Response to comment #146 and #147 , IEEE802.3bt Draft D1.4.

Response to comment #146 and #147 , Yair Darshan. November 2015.

1. Replace Figure 33B-1 from:

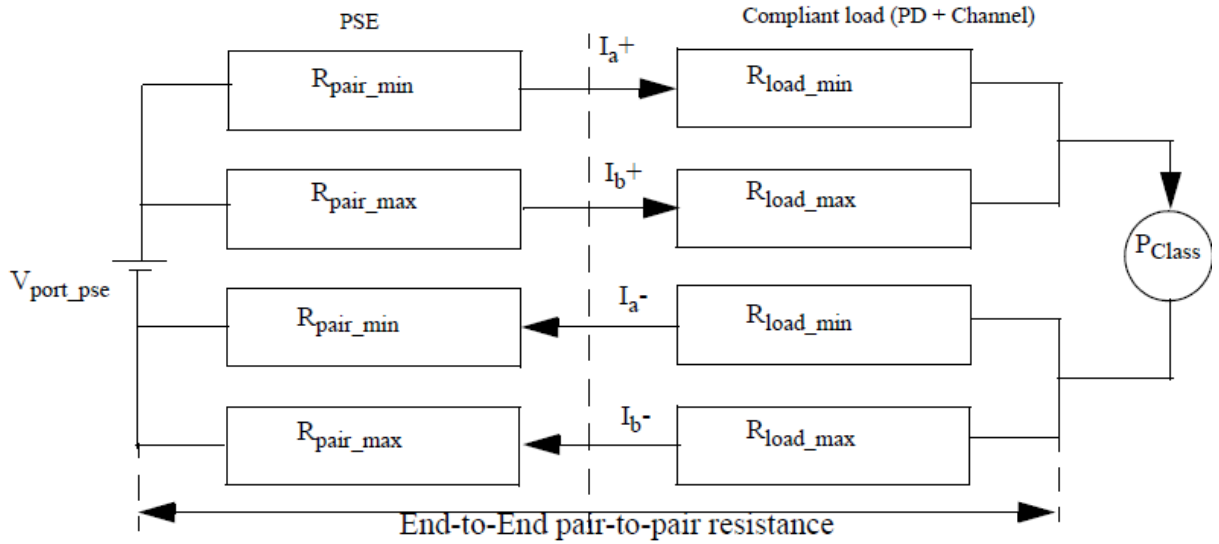
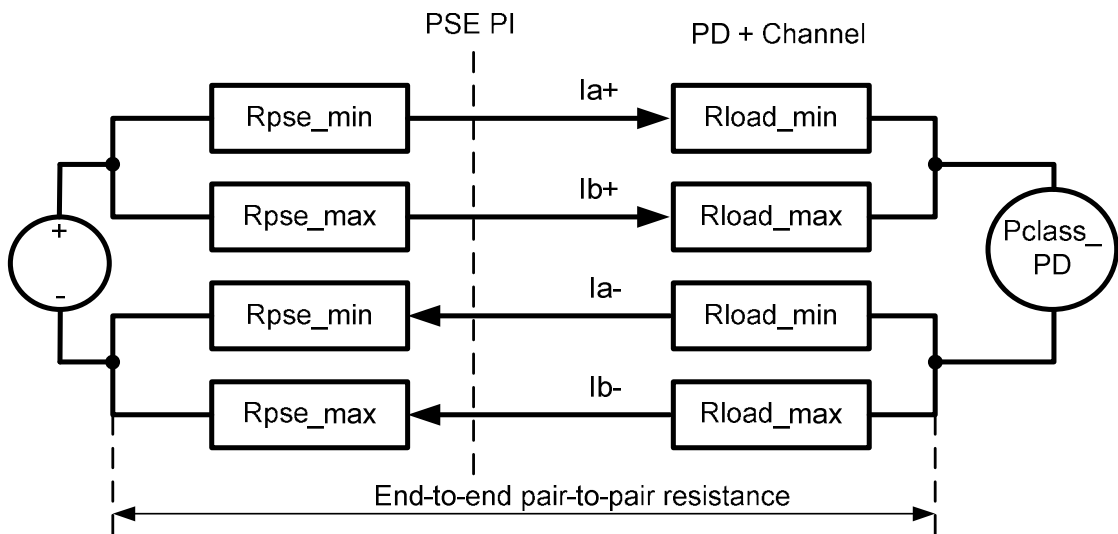
To:
